Staff Analysis of Proposed Amendment to the *Dane County Water Quality Plan*, Revising the Cambridge Urban Service Area Boundary and Environmental Corridors in the Village of Cambridge

1. Applicant: Village of Cambridge

Map 1
Amendment
to the Cambridge
Urban Service Area,
Village of Cambridge

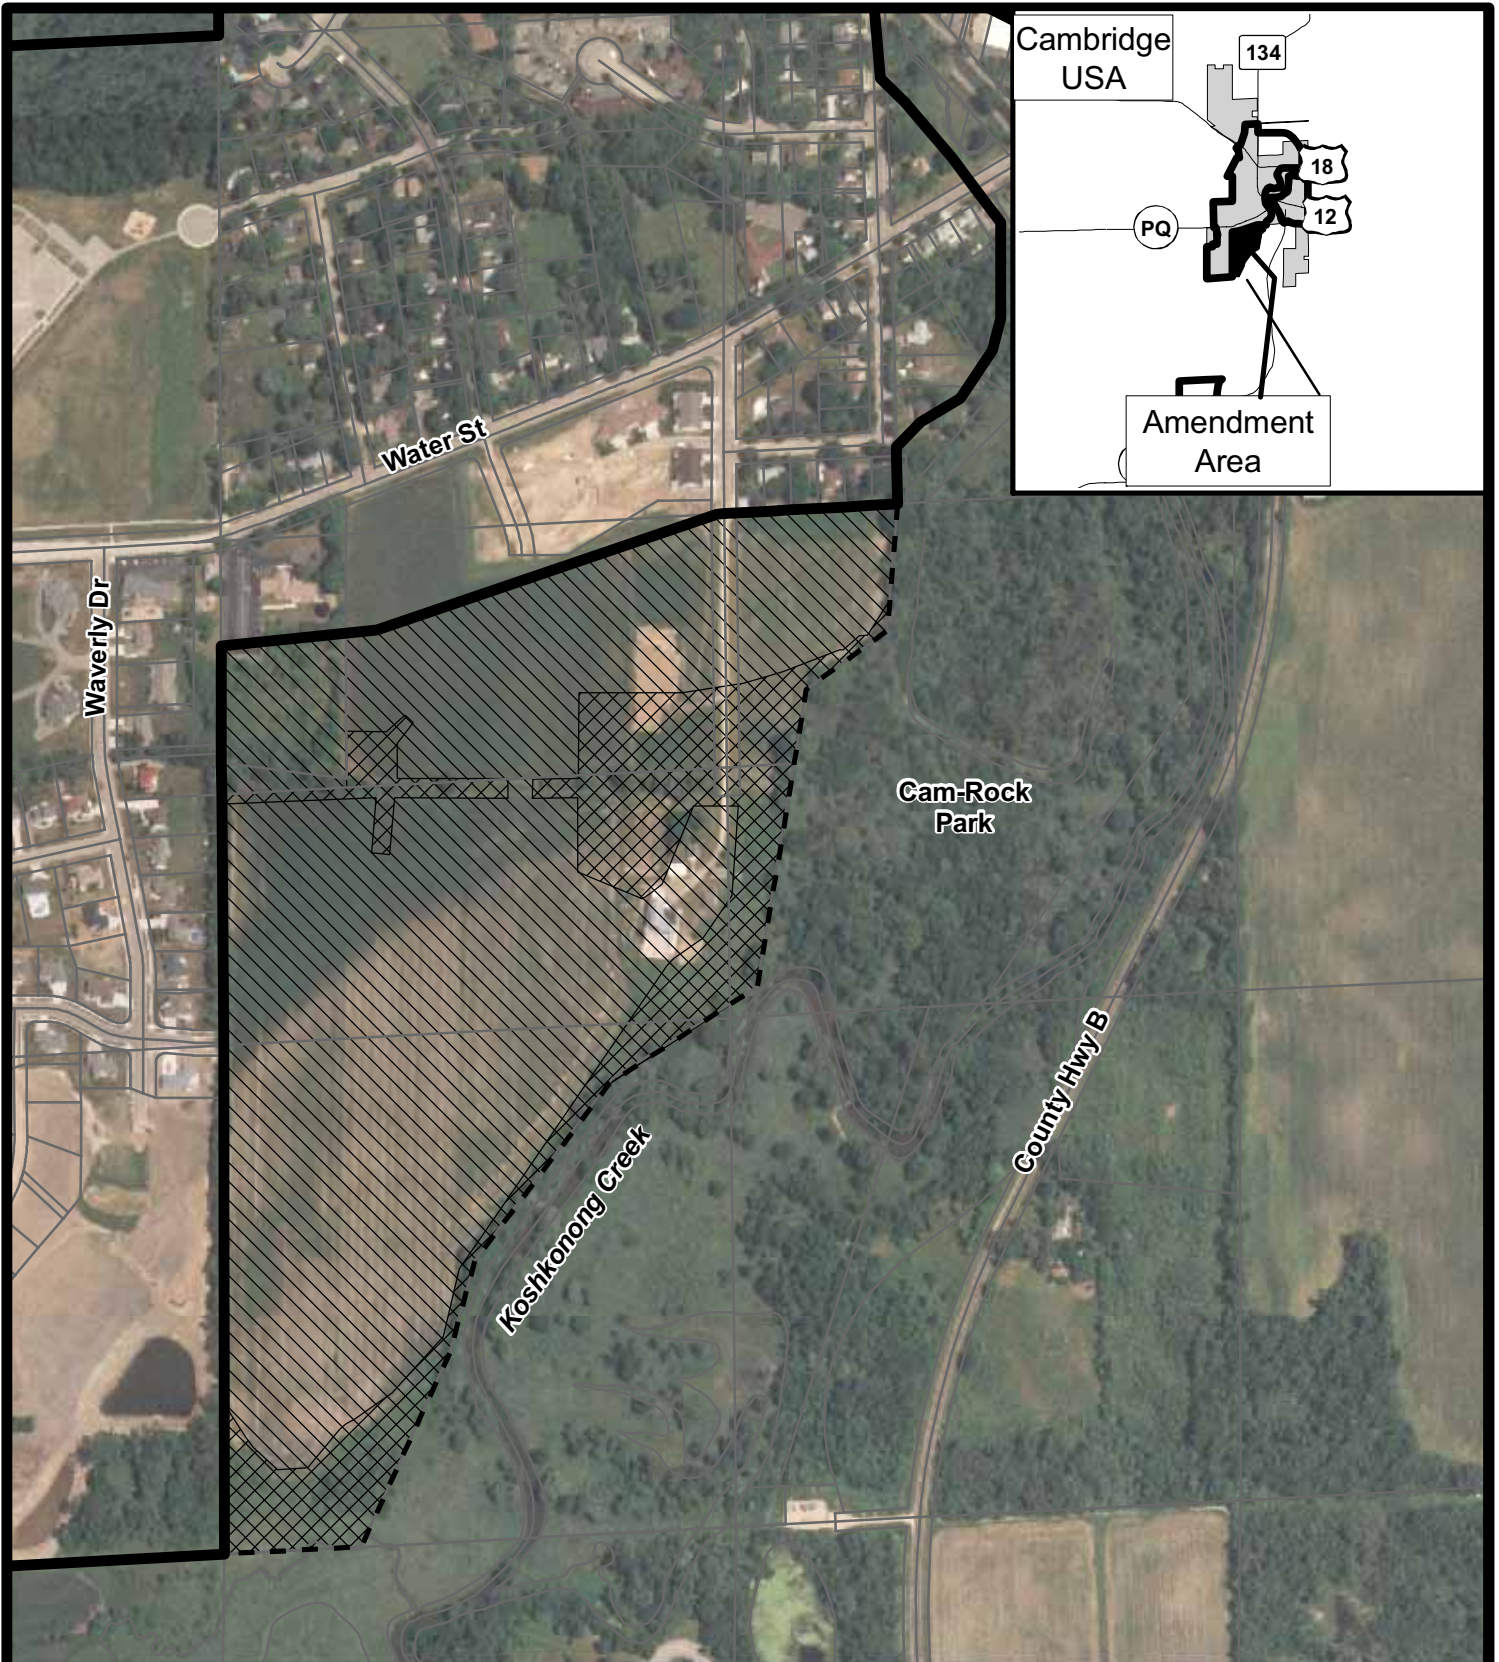
The amendment adds 62.6 acres to the Cambridge Urban Service Area, including 13.7 acres of environmental corridor and 4.6 acres of existing development, for a net added developable area of 44.3 acres (see maps 1, 2, and 3). The amendment area is located south of CTH PQ (Water Street), west of Koshkonong Creek, and northwest of CamRock Park, in the Village of Cambridge. The amendment area is planned for residential development. The proposal calls for 96 single-family housing units and 38 duplex units, for a total of 134 housing units. These units will accommodate about 316 residents, including 70 school children.

**Map 4 Soil Characteristics
Amendment
to the Cambridge
Urban Service Area,
Village of Cambridge**

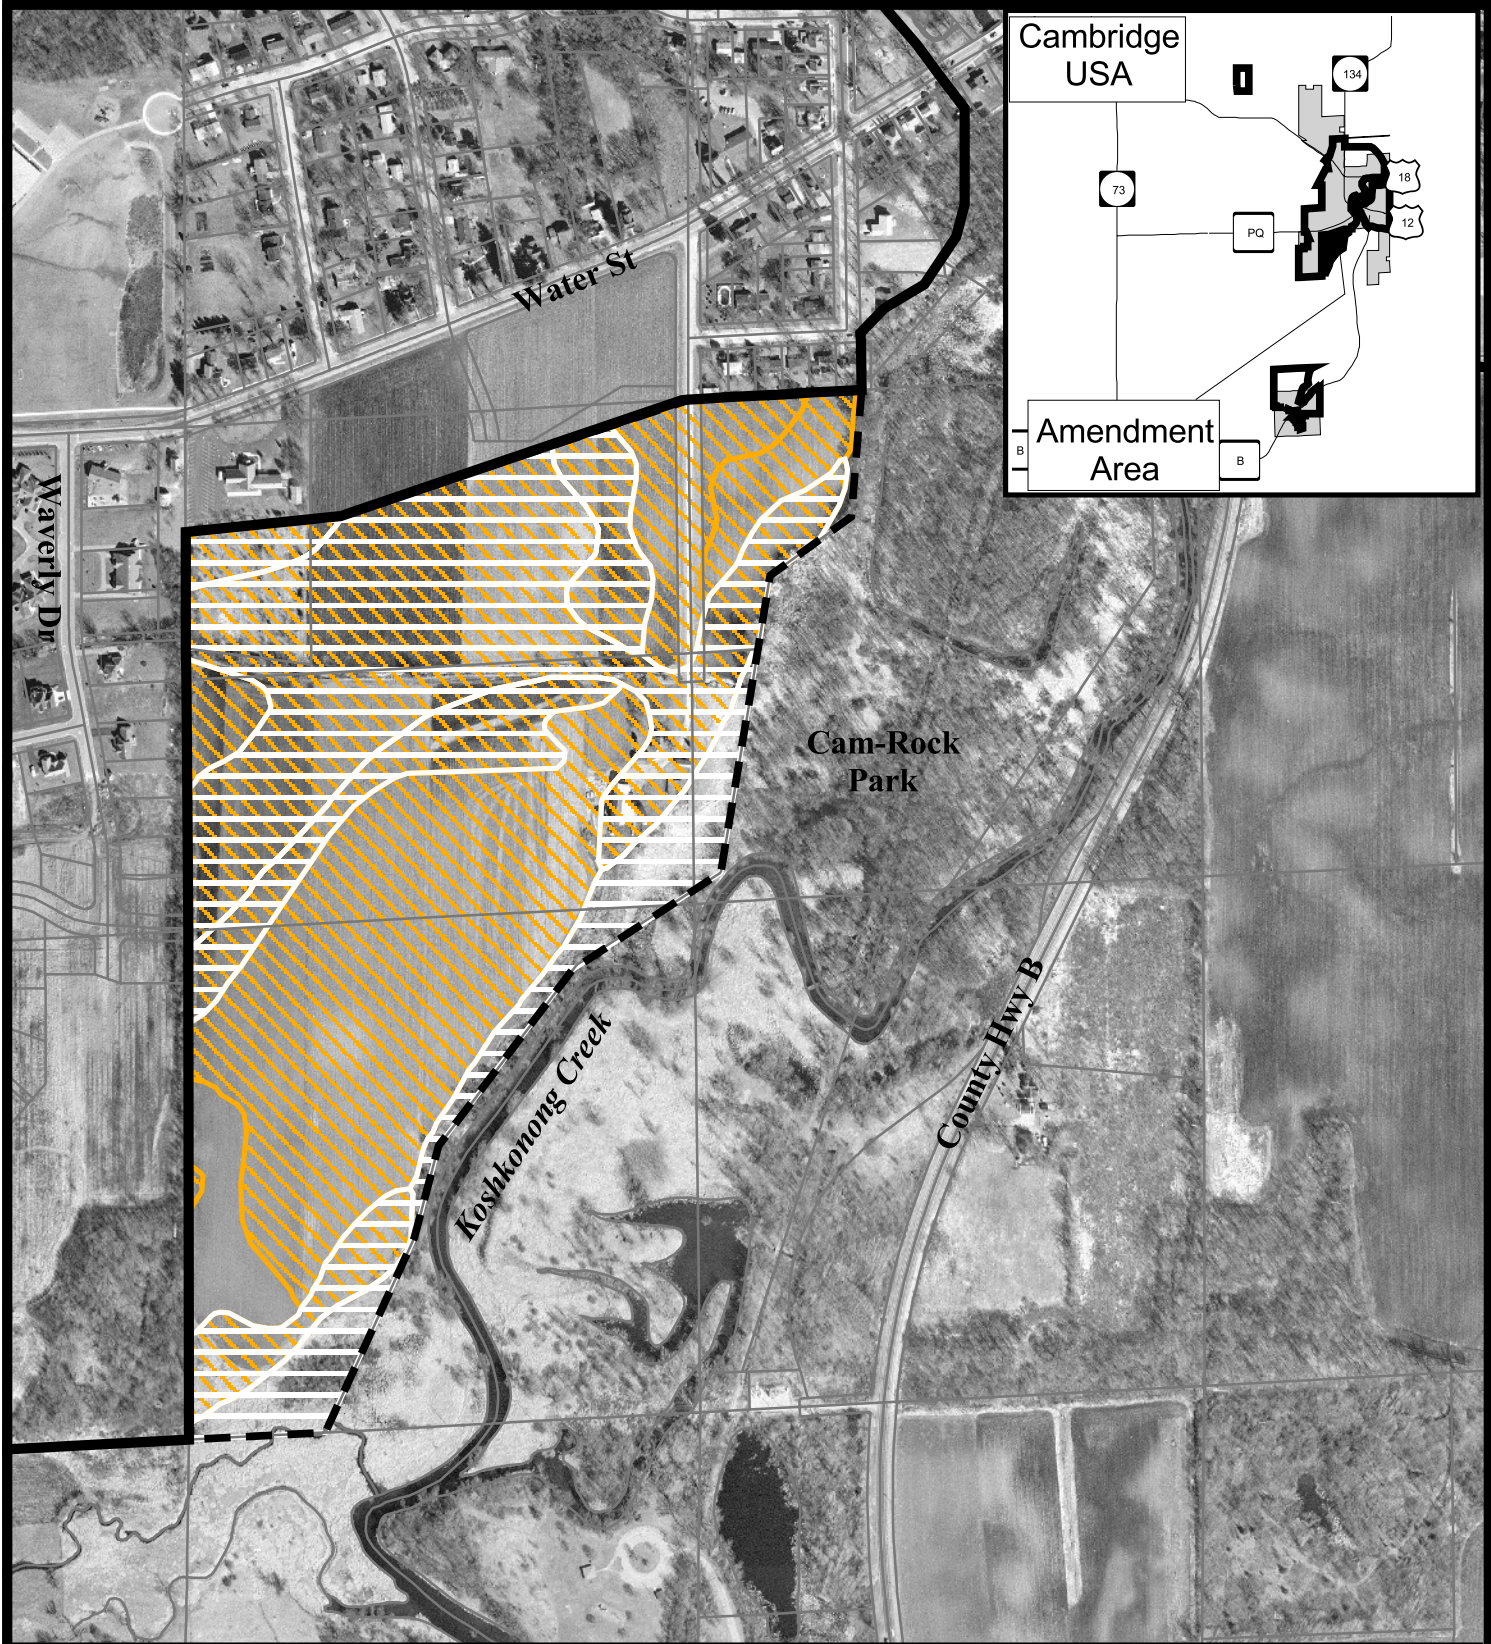
Although a portion of the amendment area with problem soils is proposed for inclusion in environmental corridors, there are areas proposed for development in the north half of the amendment area composed of Wacousta and Virgil soils. These soils pose severe limitations to development due to seasonally high water table and poor stability. Construction in these areas, especially of structures with basement, can result in the seasonal flooding of the basement and premature failure of foundation walls. The Village should provide additional oversight in these areas to ensure that proper design and construction methods are used.

Details of soil characteristics for the amendment area are summarized in Table 2 on the next page (also see Map 4).

- 1) Provide oversight for the design and construction of structures in areas that pose severe or very severe limitations for development due to seasonally high water table and poor stability.
